HISTORIC AND DESIGN REVIEW COMMISSION

January 19, 2022

HDRC CASE NO: 2021-624
ADDRESS: 702 HAYS ST
LEGAL DESCRIPTION: NCB 540 BLK 11 LOT A16
ZONING: R-5, H
CITY COUNCIL DIST.: 2
DISTRICT: Dignowity Hill Historic District
APPLICANT: Kuba Zarobkiewicz/ZAROBKIEWICZ KUBA
OWNER: Kuba Zarobkiewicz/ZAROBKIEWICZ KUBA
TYPE OF WORK: Construction of a 2nd-story addition
APPLICATION RECEIVED: November 23, 2021
60-DAY REVIEW: Not applicable due to City Council Emergency Orders
CASE MANAGER: Rachel Rettaliata

The applicant is requesting conceptual approval to:

LEFT SIDE ELEVATION
SCALE: 1/4" = 1'-0"

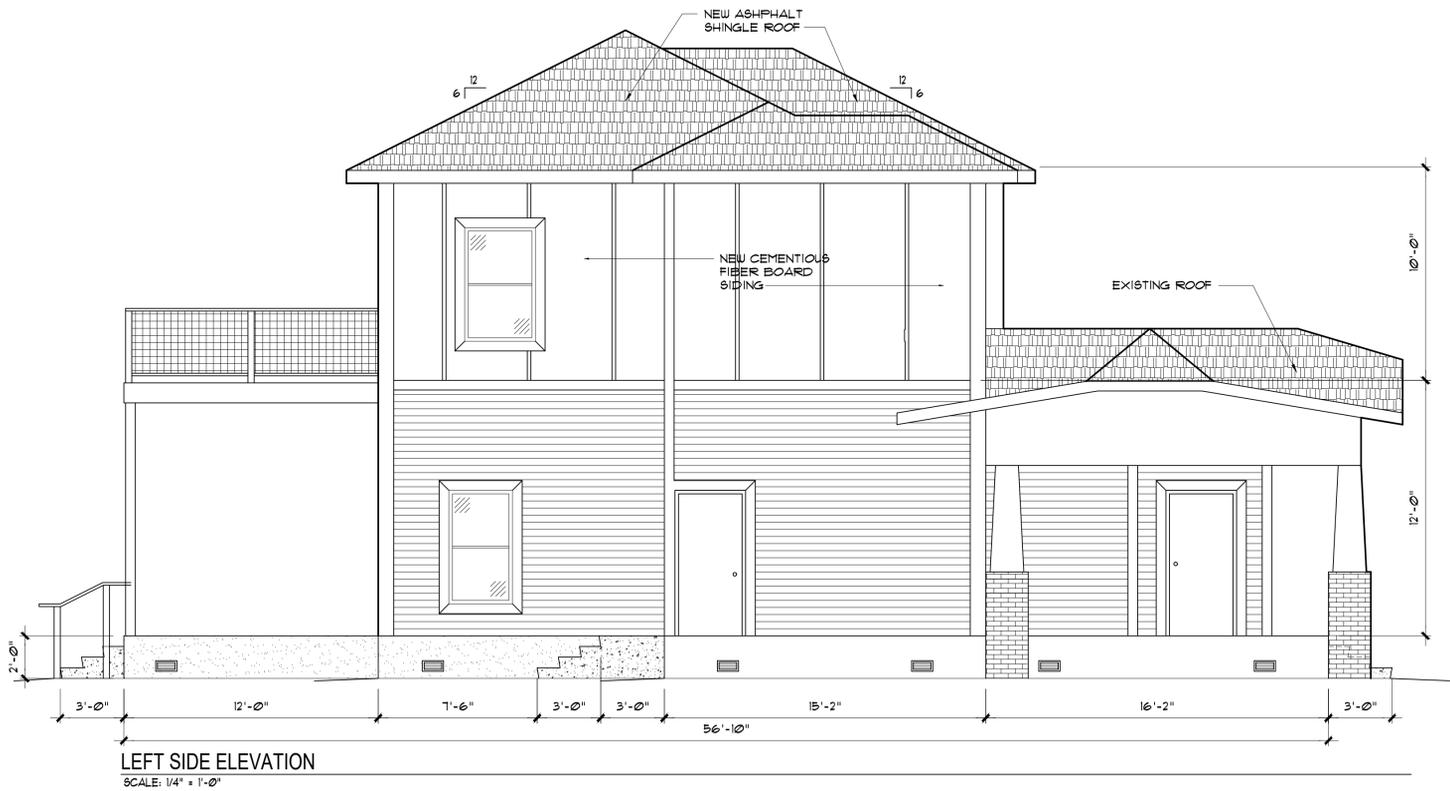
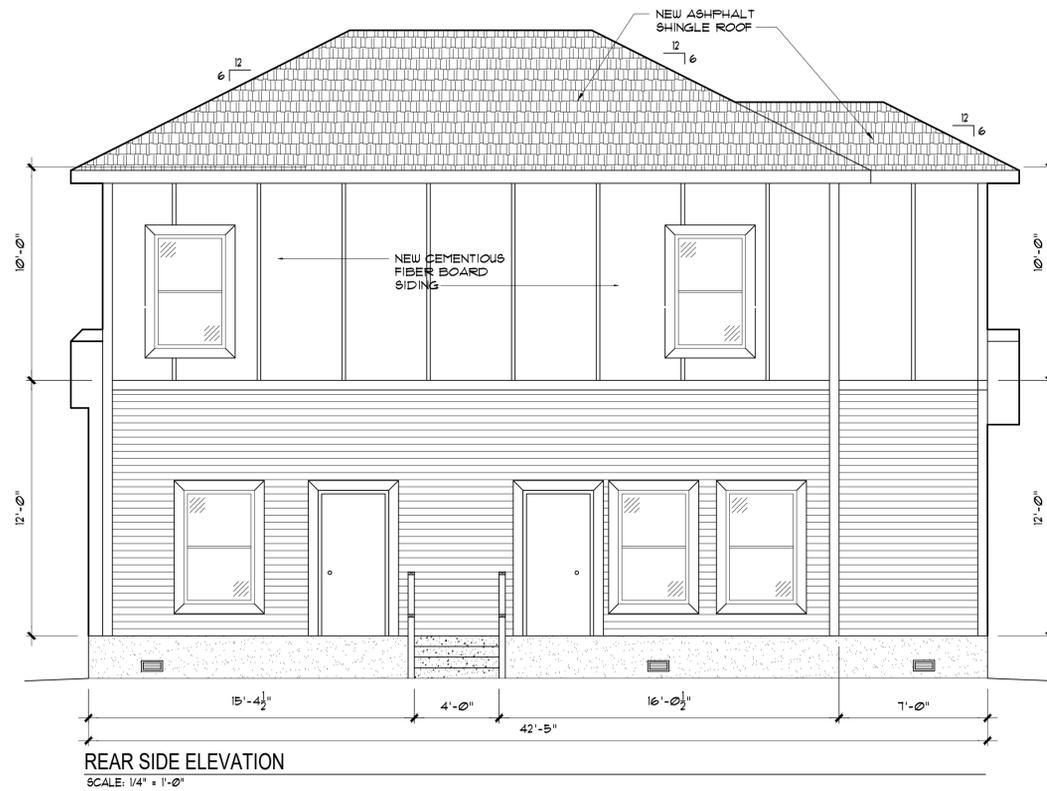
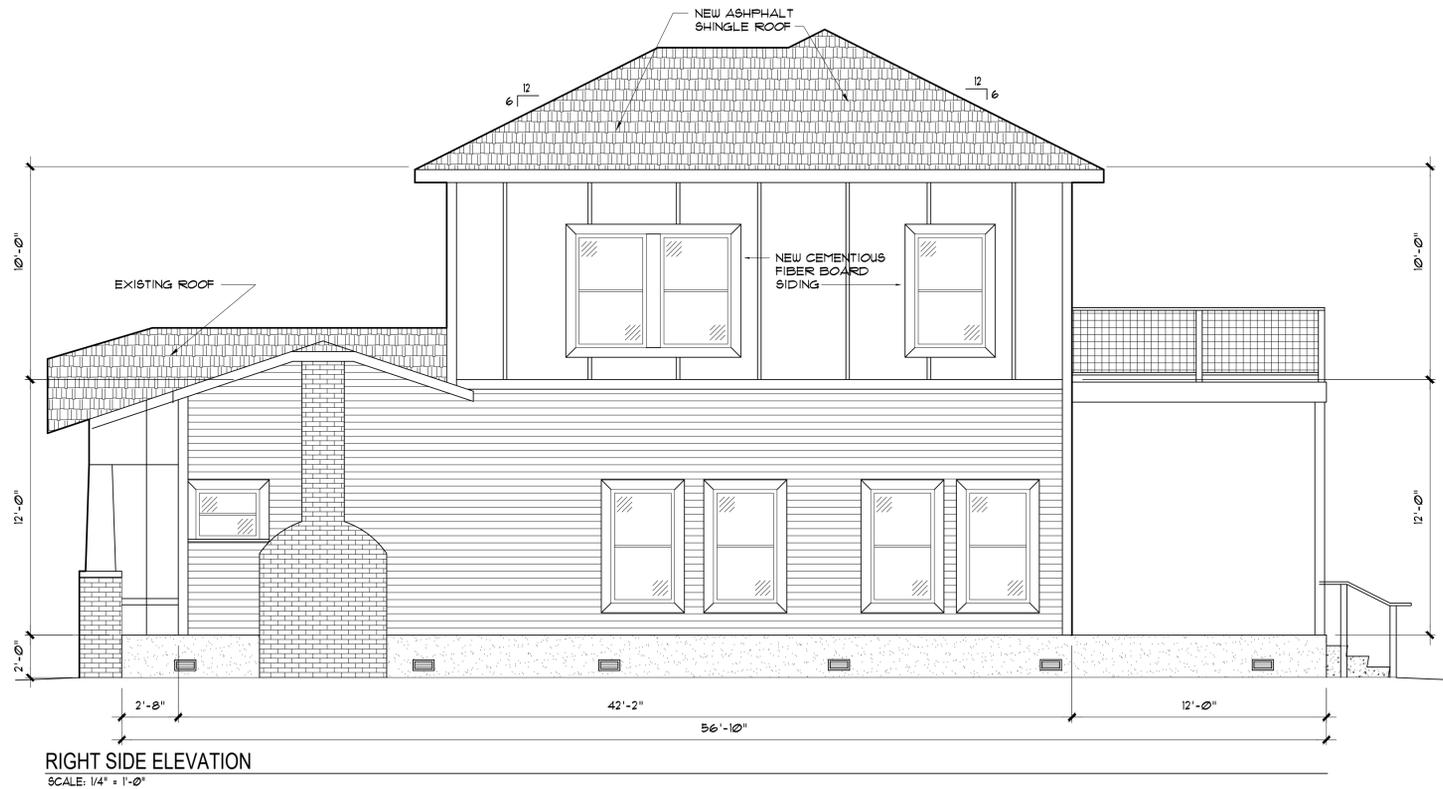
- i. FENESTRATION MODIFICATION: NORTH (FRONT) FACADE – The applicant has proposed to modify the fenestration pattern on the front façade to feature a small non-traditional window in place of the existing ganged one-over-one windows. Guideline 6.A.i for Exterior Maintenance and Alterations states that existing window and door openings should be preserved. Avoid enlarging or diminishing to fit stock sizes or air conditioning units. Avoid filling in historic door or window openings. Avoid creating new primary entrances or window openings on the primary façade or where visible from the public right-of-way. Staff finds that proposed fenestration modification inconsistent with the Guidelines.

- j. FENESTRATION MODIFICATION: EAST ELEVATION – The applicant has proposed to modify the fenestration pattern on the east elevation to enclose four (4) existing window openings and install a solid door. Guideline 6.A.i for Exterior Maintenance and Alterations states that existing window and door openings should be preserved. Avoid enlarging or diminishing to fit stock sizes or air conditioning units. Avoid filling in historic door or window openings. Avoid creating new primary entrances or window openings on the primary façade or where visible from the public right-of-way. Staff finds that proposed fenestration modification inconsistent with the Guidelines.

- k. FENESTRATION MODIFICATION: SOUTH (REAR) ELEVATION – The applicant has proposed to modify the fenestration pattern on the south (rear) elevation to enclose one (1) existing window opening on the east side of the elevation, install a new door opening on the west side of a new set of steps and re-orient the existing window and door openings on the west side of the rear elevation. Guideline 6.A.i for Exterior Maintenance and Alterations states that existing window and door openings should be preserved. Avoid enlarging or diminishing to fit stock sizes or air conditioning units. Avoid filling in historic door or window openings. Avoid creating new primary entrances or window openings on the primary façade or where visible from the public right-of-way. Staff finds that proposed fenestration modification inconsistent with the Guidelines.

- l. FENESTRATION MODIFICATION: WEST ELEVATION – The applicant has proposed to modify the fenestration pattern on the west elevation to enclose one (1) existing window opening on the south side of the chimney, enclose a second small window opening, remove the non-original aluminum windows located on the south side of the west elevation, and install two (2) traditionally-sized windows on the south side of the west elevation. Guideline 6.A.i for Exterior Maintenance and Alterations states that existing window and door openings should be preserved. Avoid enlarging or diminishing to fit stock sizes or air conditioning units. Avoid filling in historic door or window openings. Avoid creating new primary entrances or window openings on the primary façade or where visible from the public right-of-way. Staff finds that the three aluminum windows located toward the south side of the west elevation are likely not original to the structure. Staff finds that the removal of the small window to the south of the chimney is inappropriate, but the proposed fenestration modifications to the south side of the west elevation are appropriate.

JF: It looks like we've removed the clipped gable over the capped chimney, can you update the elevation drawing to show the gable as it exists?

MS: It looks like we are missing a window on the right side of the chimney, is that due to interior modifications?

Items 2, 3, and 4, staff does not recommend approval of fenestration modifications based on findings i through k.

Item 5, staff recommends approval of fenestration modifications on the west elevation based on finding l with the following stipulations:

- i. That the applicant retains the small window on the south side of the chimney.
- ii. That the applicant salvages the small window removed from the west elevation and stores the window on site for use in future rehabilitation or construction.
- iii. That the applicant submits final material specifications for fully wood windows to staff for review and approval prior to the issuance of a Certificate of Appropriateness. Windows should feature an inset of two (2) inches within

FRONT STREET (HAYS ST.) VIEW - 702 HAYS ST.

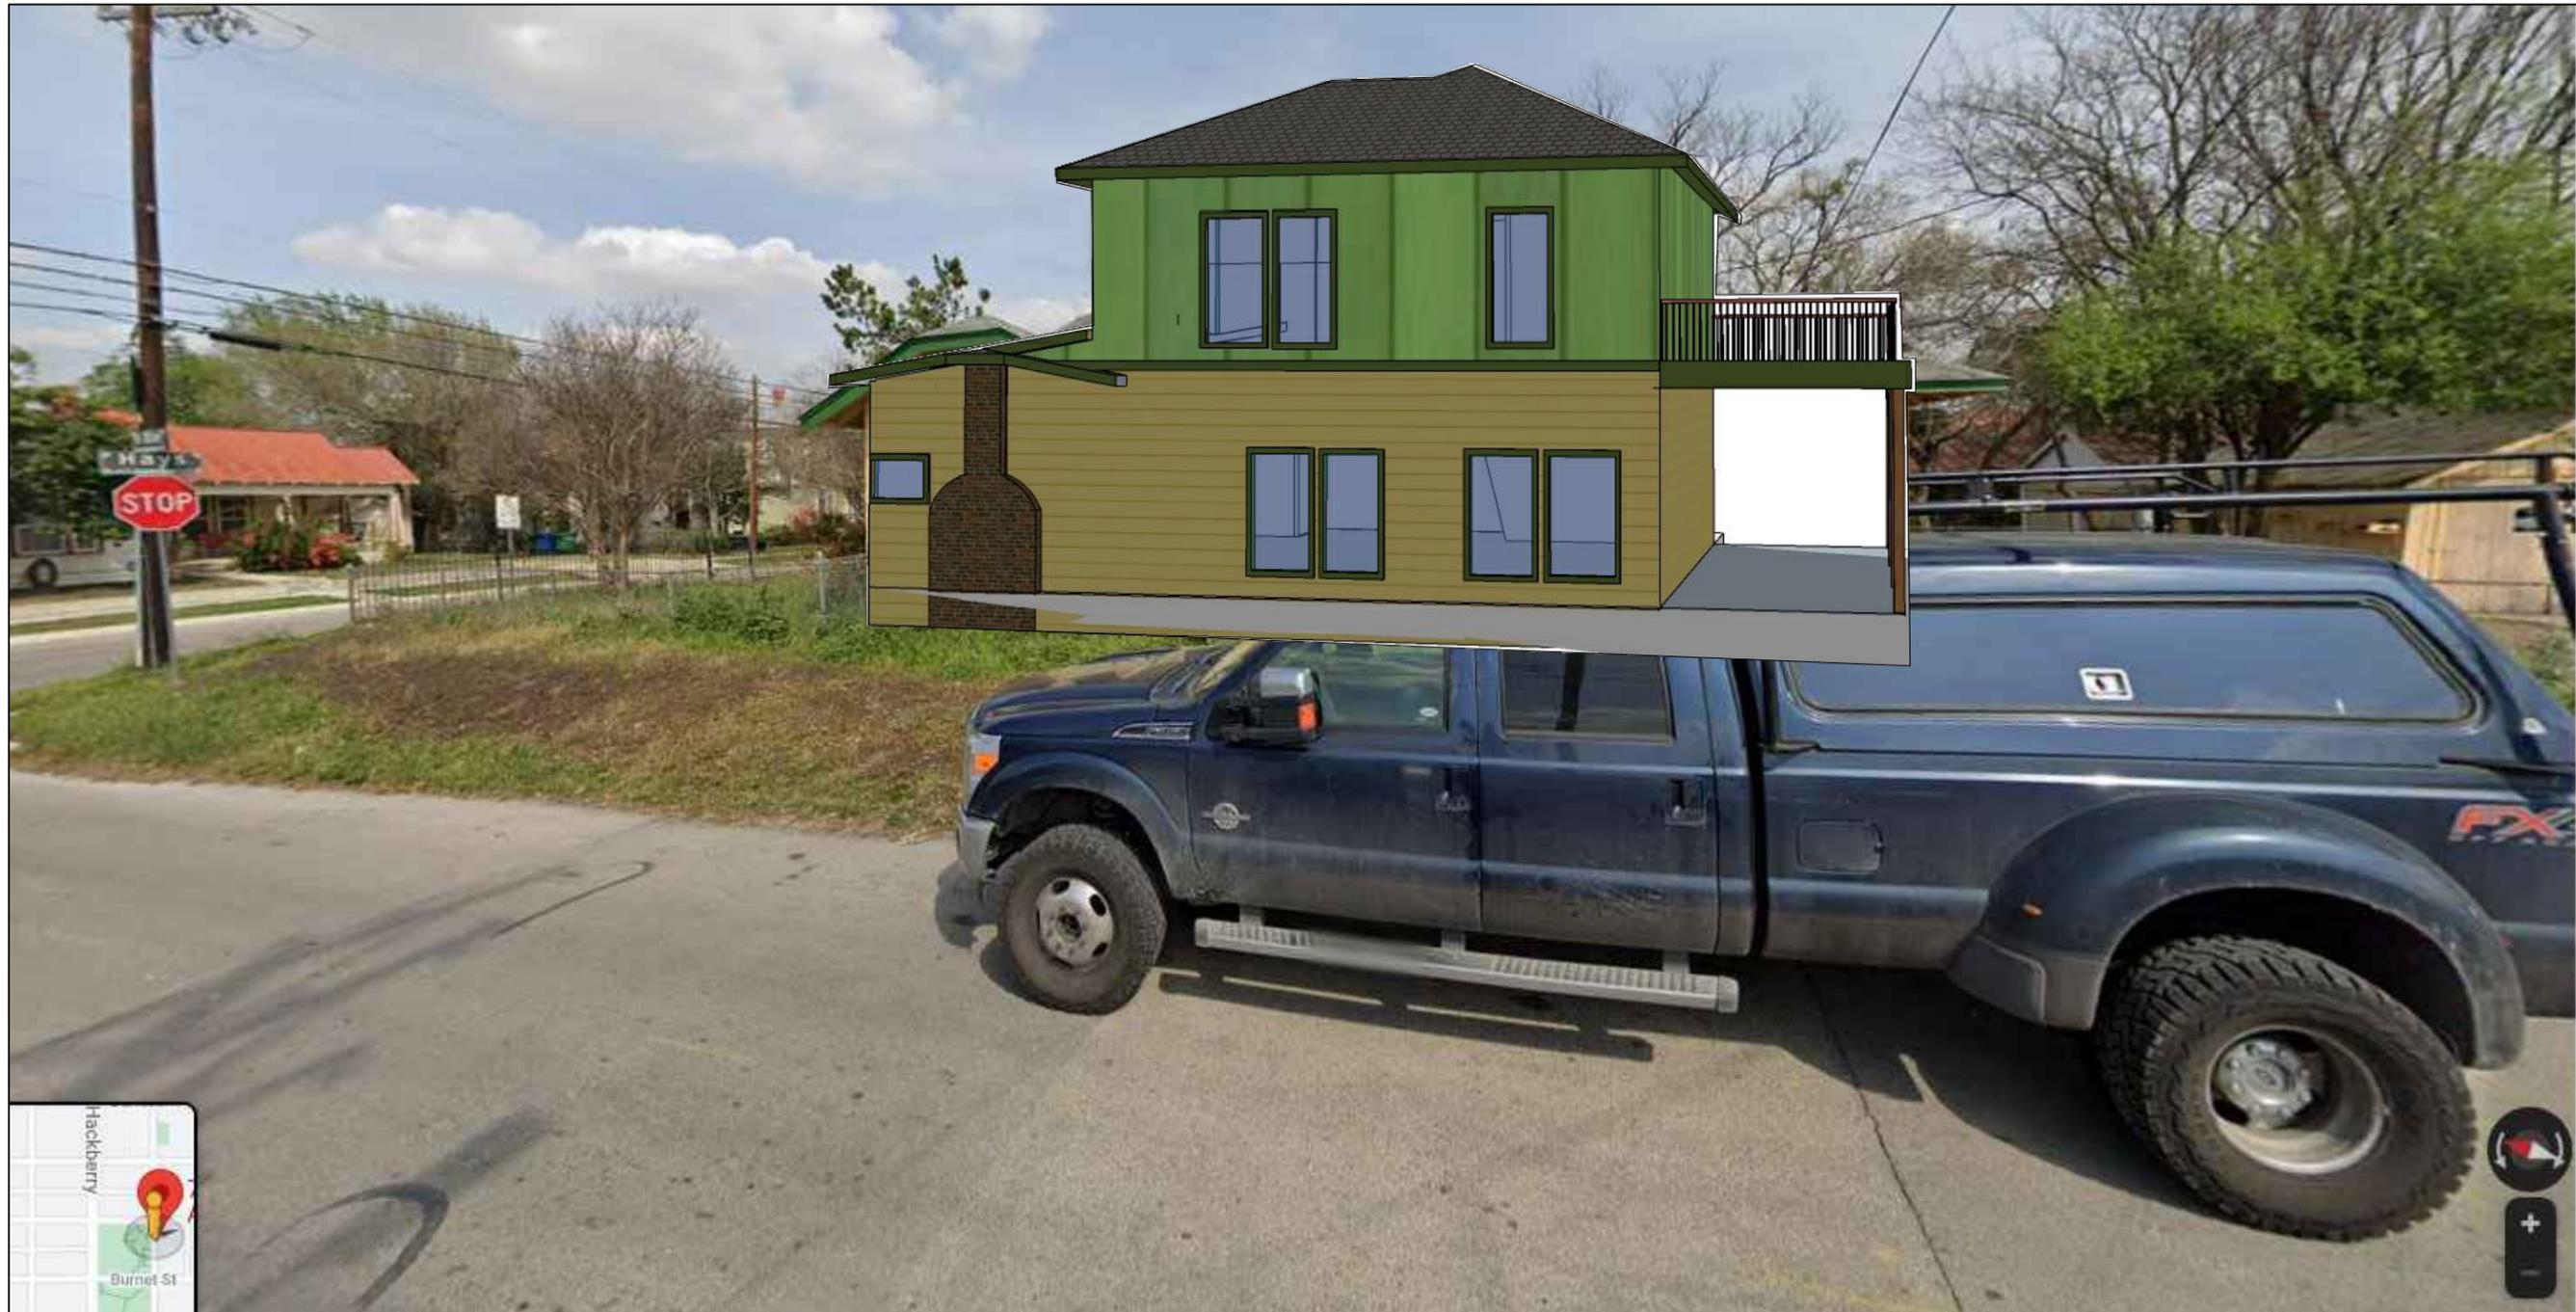
- d. ADDITION: MASSING AND FOOTPRINT – The applicant has proposed to construct a second-story rear addition set back 16'-2" from the front façade wall plane. The rear addition will be approximately 800 square feet. Guideline 1.A.i. for Additions states that residential additions should be sited at the rear of the building whenever possible to minimize views of the addition from the public right-of-way, an addition to the front of a building would be inappropriate. Guidelines 1.A.ii. for Additions states that new residential additions should be designed to be in keeping with the existing, historic context of the block. For example, a large, two-story addition on a block comprised of single-story homes would not be appropriate. According to Guideline 1.B.v, the height of new additions should be determined by examining the line-of-sight or visibility from the street. Addition height should never be so contrasting as to overwhelm or distract from the existing structure. The Guidelines stipulate that residential additions should not be so large as to double the existing building footprint, regardless of lot size. The existing building is 1,200 square feet. Staff finds the proposed footprint appropriate; however, the proposed massing may distract from the existing structure. Staff finds that the applicant should submit a line-of-sight study for review.

MS: I understand your concerns with impacting the original house, when we begin to modify the existing house noted for being modest and we add a second floor, square footage, suddenly the character has changed in a very dramatic way. What I'm wondering is, have you pursued a plan to give you square footage on one floor instead of going up?

- i. That the applicant submits a line-of-sight study showing the visibility of the 2-story rear addition from the public right-of-way.
- ii. That the applicant simplifies the proposed roof form on the addition to reduce the visibility from the public right-of-way based on finding e.
